#### 16jm Ad Hoc Group Recommendations on 16j/16m Relay Connection Chart

IEEE C802.16m-08/497

For informing TGm about the discussions that took place in the 16jm AHG regarding 16j/16m interoperability.

# Objections/Comments received

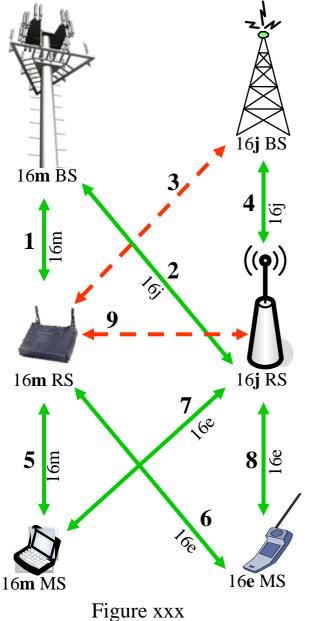
- Connection 2 (16m BS 16j RS): 1 objection
  - Objection: For the exact reason for objection, see Appendix A (at the end).
  - Remark from the chairs: Objection is noted. Will be captured in the final report.

- Connection 6 (16m RS 16e MS): 1 comment
  - Comment: 'In the case of connection 6 (16m RS to 16e MS), support for the connection should be conditional based upon the usage model.'

- Remark from the chairs: When and under what circumstances a connection is to be used will be discussed during the detailed text development phase.
- Connection 9 (16m RS 16j RS): 1 objection

- Objection: It is premature to rule out the #9 connection: "16m RS 16j RS" at this stage. We should keep this connection until the survey results on the basic constructs for the usage models are finalized.

- Remark from the chairs: Objection is noted. Will be captured in the report.
- Additional connection (MS-RS-MS) proposal
  - Proposal: From the inputs on the 16jm e-mail reflector (as of April 25, 2008), many companies have expressed the desire to support basic construct #7 "local forwarding" (MS1↔RS↔MS2) using relays from MITRE to be placed here.

- Remark from the chairs: The current connection chart is primarily for discussions related to legacy RS support. End-to-End connectivity constructs (e.g. MS-RS-MS) are dealt with in the "Basic Usage Model Constructs" discussion.

- The objections to connection 2 and 9 have been noted. These will be captured in the AHG report. It should be noted that support for connection 2 was unanimously agreed in the joint TGm/TGj session of the March meeting.
- The discussion on the 16m Relay Connection chart, within this AHG, is now closed.
- The draft of the material (text/table/Figure) which will be recommended by this AHG to the TG for inclusion in the SDD, is shown in the next two slides.
- You are invited to comment on whether the proposed material (text/table/figure) accurately capture the agreed upon connections.

Objections raised on connection 2

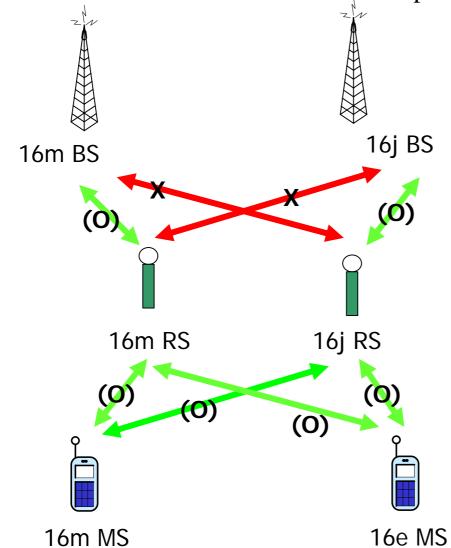
• Problem: Should Connection-2 which is the one between 16m BS and 16j RS be supported?

- In the current connection configuration, 16m BS can operate with 16j RS. It means 16m BS has to include the capabilities same with 16j BS. In other words, 16m BS has to fully backward support 16j BS.
- But according to the legacy supporting requirement in 16m SRD, the legacy reference system is defined by WiMAX Mobile System Profile, which does not include the definition of 16j BS.
- So if 16m BS can operate with 16j RS, the capability of backward compatibility of 16m BS is extended to support 16j BS. It is out of scope of 16m SRD. And it will cause high complexity for 16m BS, because 16m BS has to support at least three air interfaces, including 16e, 16j, and 16m.

In current 16j standard, there is a lot of optional features to support the same functionality. It does not meet the complexity requirements of 16m for minimum optional features.

Even 16j profile is defined by WiMAX in the future, this connection is still not necessary. 16m RS can provide the support for both 16e MS and 16m MS to communicate with 16m BS. And 16j RS can support both 16e MS and 16m MS to communicate with 16j BS.
